ADDENDUM 01

USM Brooks Center eSports Improvements

Date: October 11, 2024

USM - Brooks Center eSports Improvements

MH101

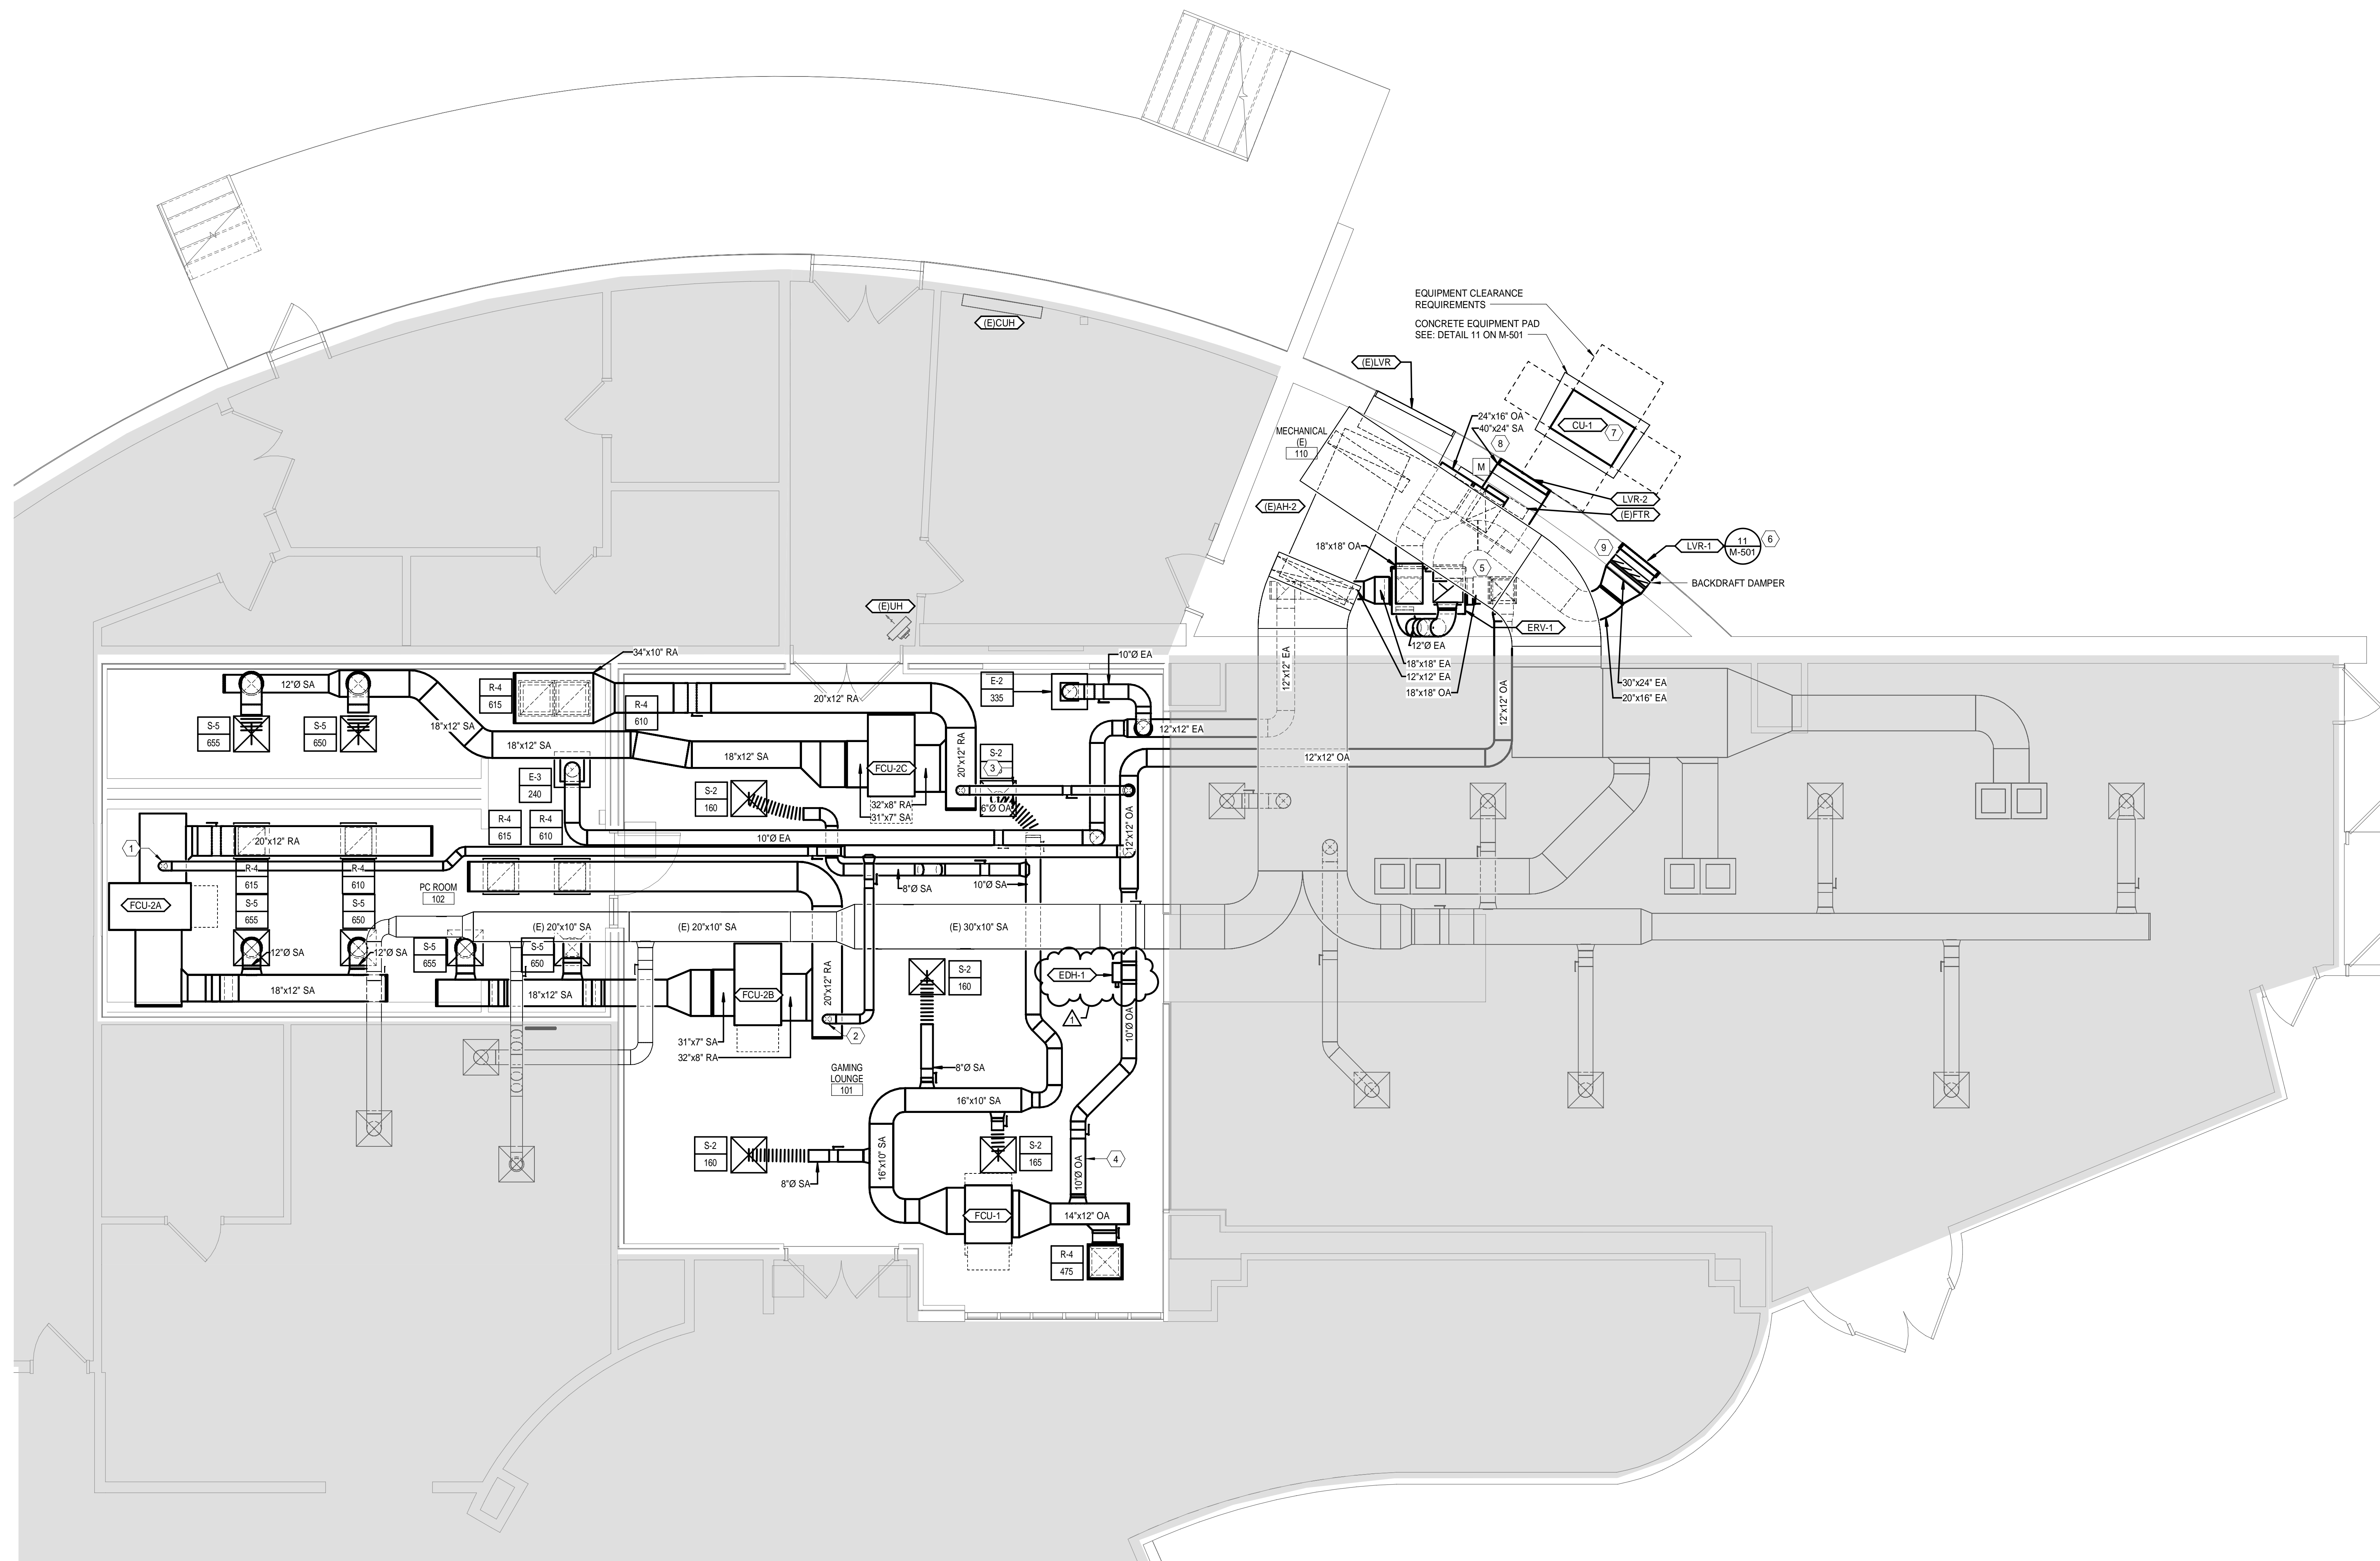
MH101 – Added electric duct heater in outside air duct serving FCU-1.

MP101

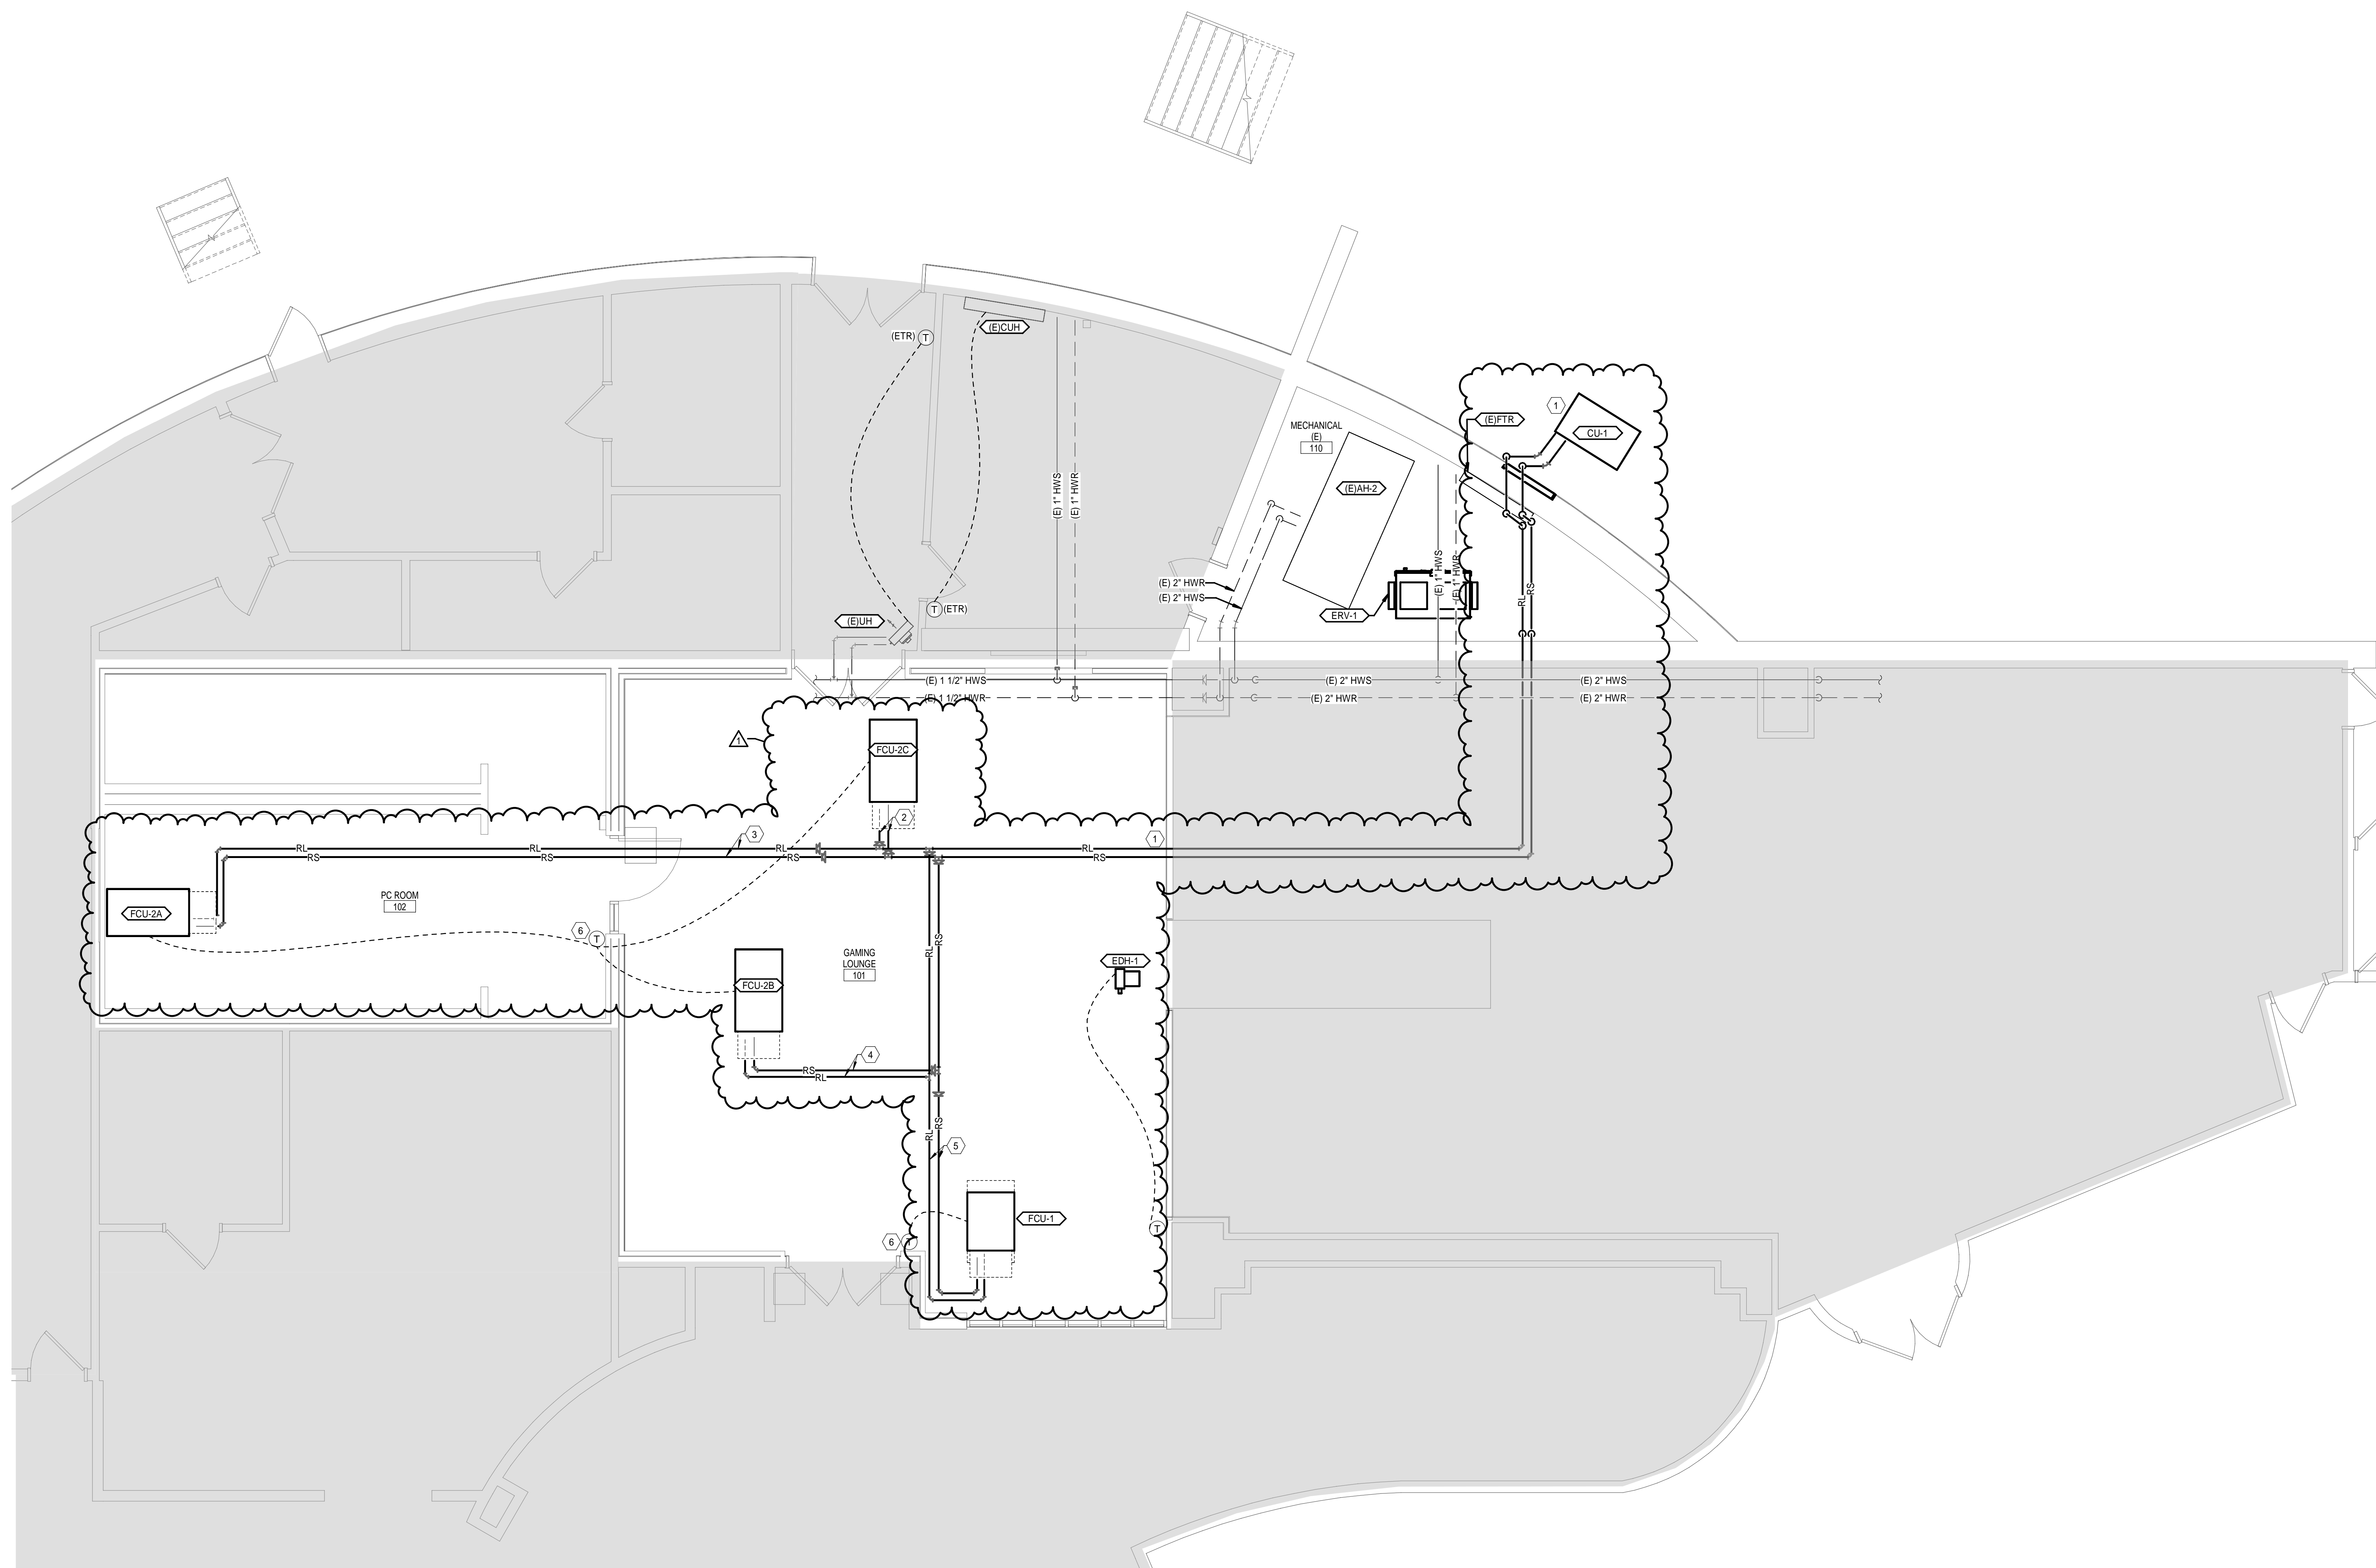
MP101 – Adjusted pipe routing to show a heat pump VRF system instead of a heat recovery VRF system.

Removed branch circuit controller because heat pump system does not use a branch circuit controller.

PL101

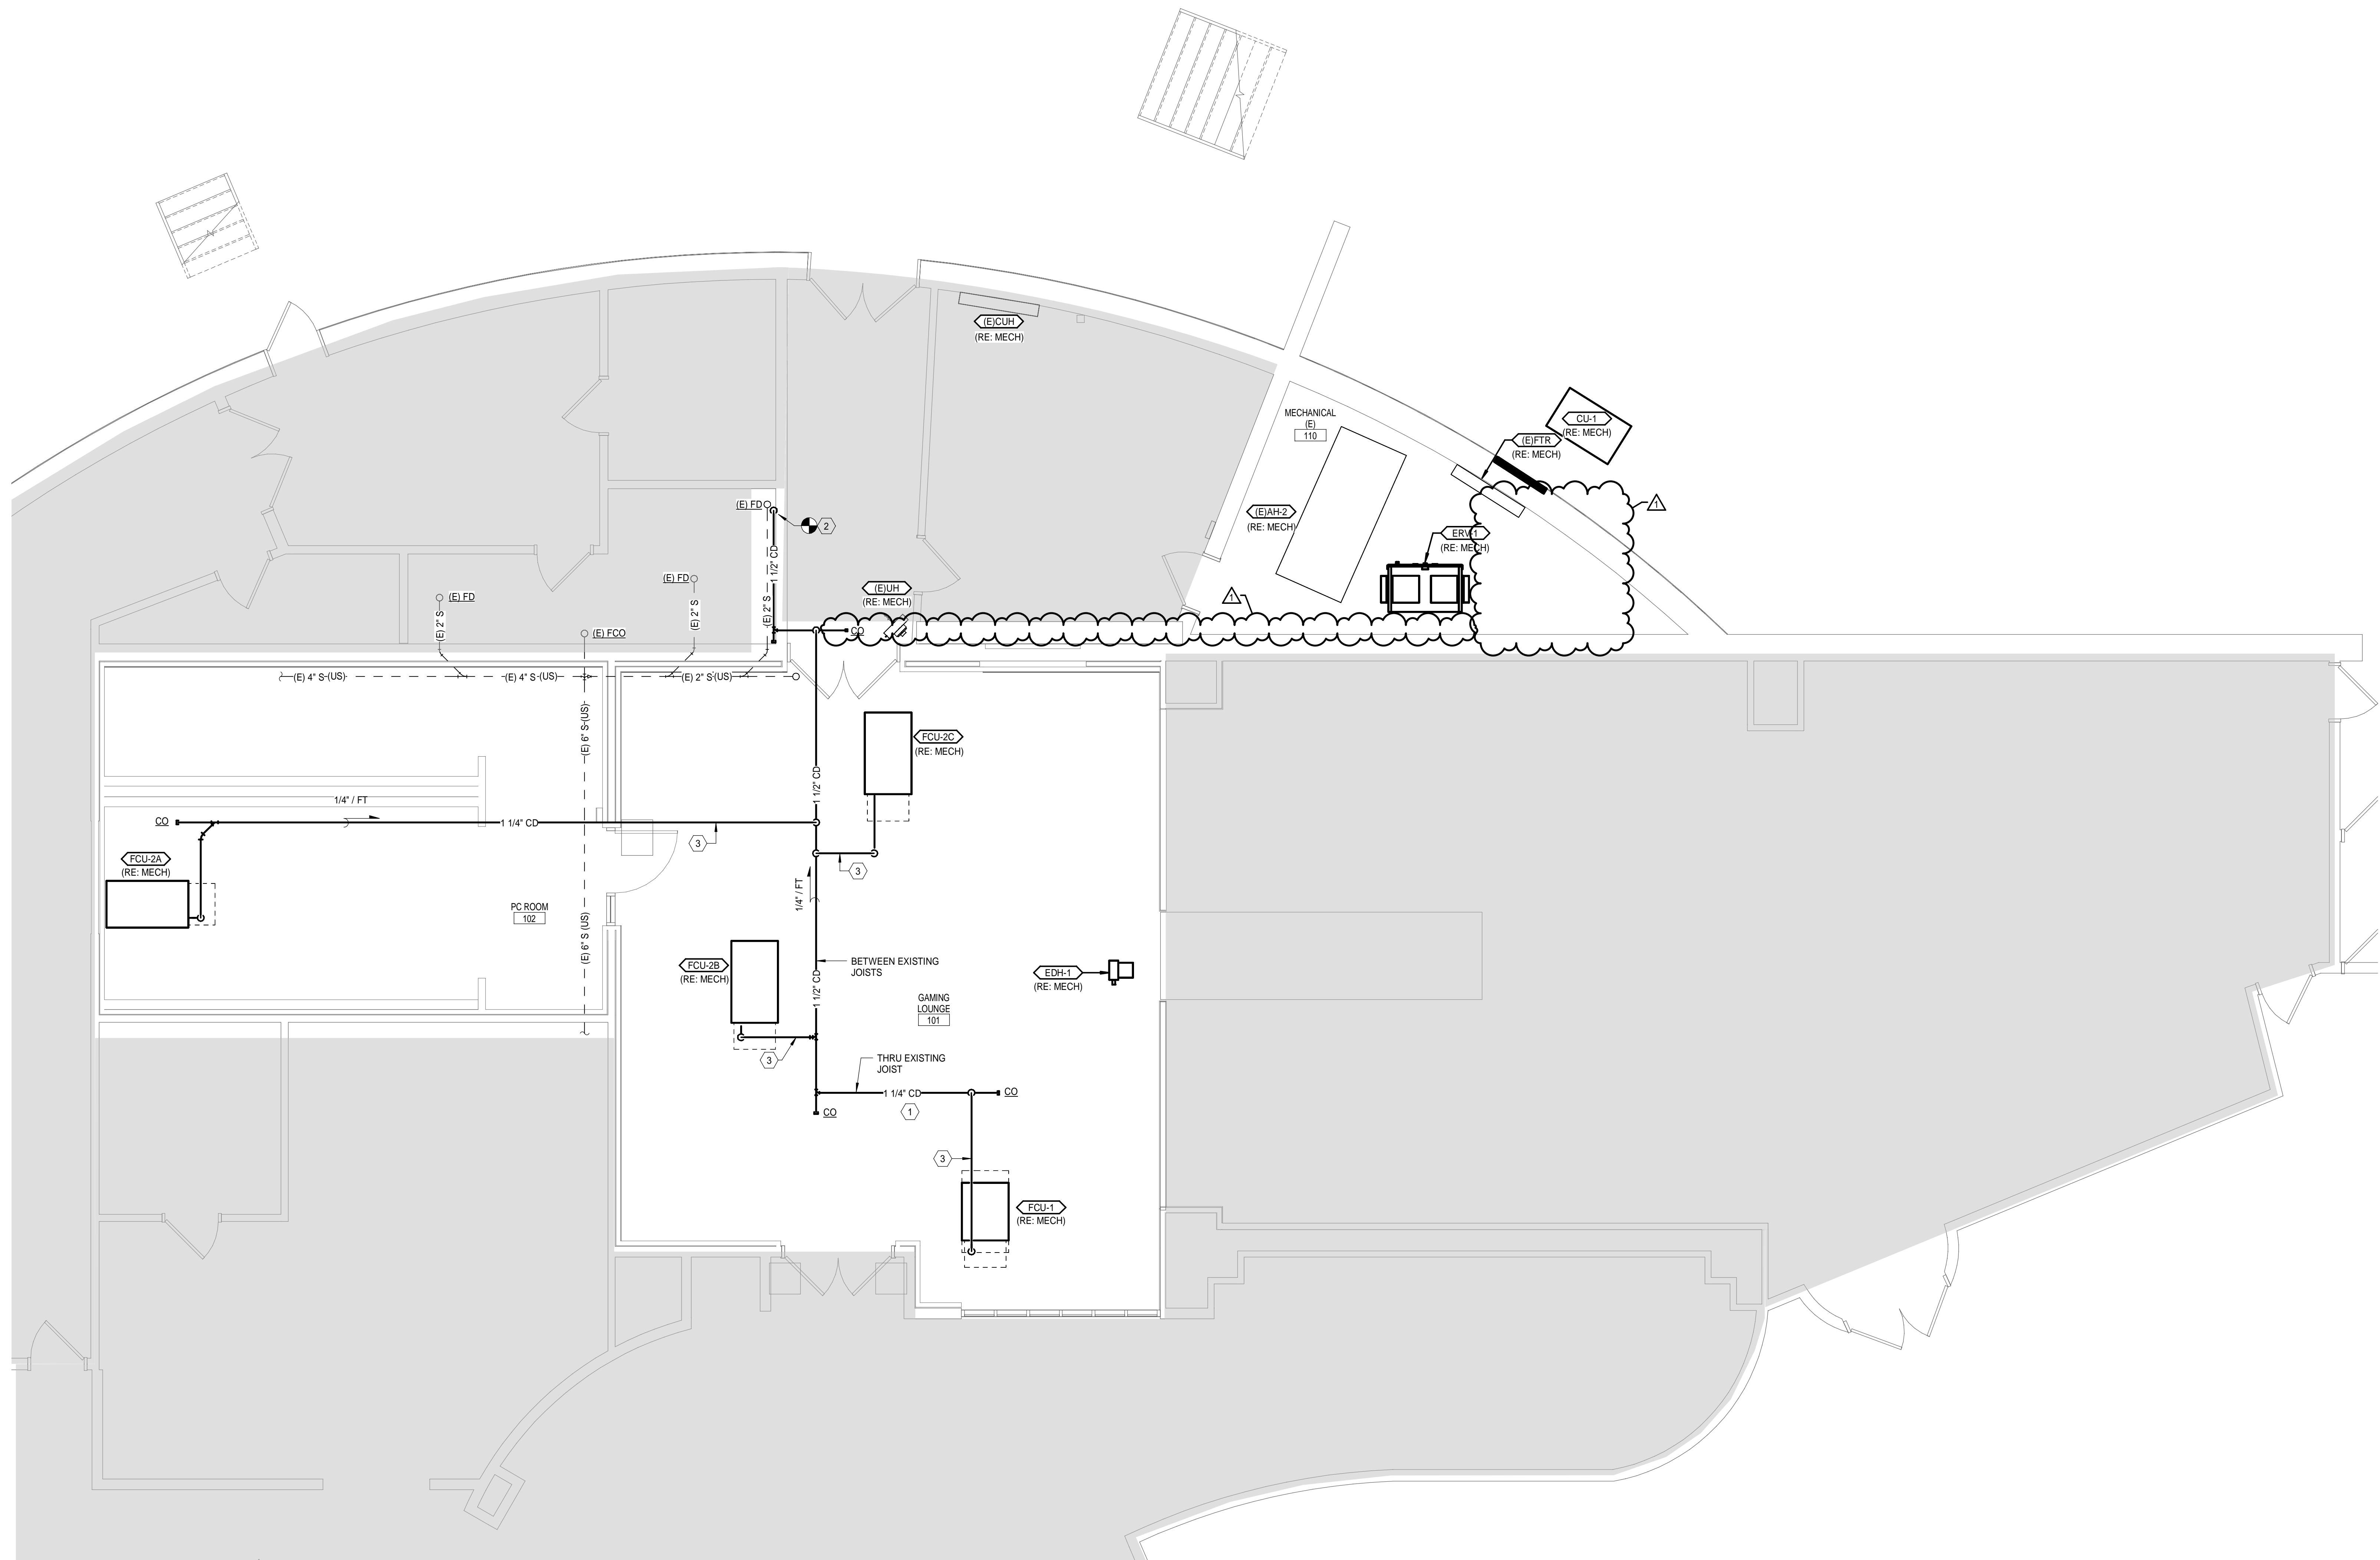
PL101 – Removed condensate drainage line serving branch circuit controller from mechanical room.
